# UNITED STATES PATENT AND TRADEMARK OFFICE

09/901,636

Thomas Malzahn

**Office Action Summary**

**FIG 5**

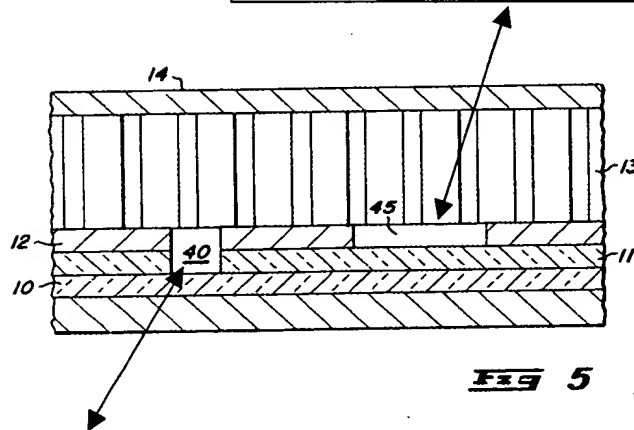
3. Applicant's arguments filed 01/28/04 have been fully considered but they are not persuasive. Applicant has argued that the written description of the slots in Belle et al. does not indicate that they are different. However, in figure 5 (shown on the next page) it can be seen that slot (40) is deeper and smaller than slot (45), which is longer and shallower than (40). This constitutes both a different dimension and a different shape from one another.
4. Any inquiry concerning this communication or earlier communications from the examiner should be directed to André K. Jackson whose telephone number is (703) 305-1522. The examiner can normally be reached on Mon.-Thurs. 7AM-4PM.

Shallow: Not as deep as (40)  
only as deep as element (12).  
Longer in width when compared  
to (40).

Deeper: Reaches down to  
element (10) from element  
(12). Smaller in width when  
compared to (45)
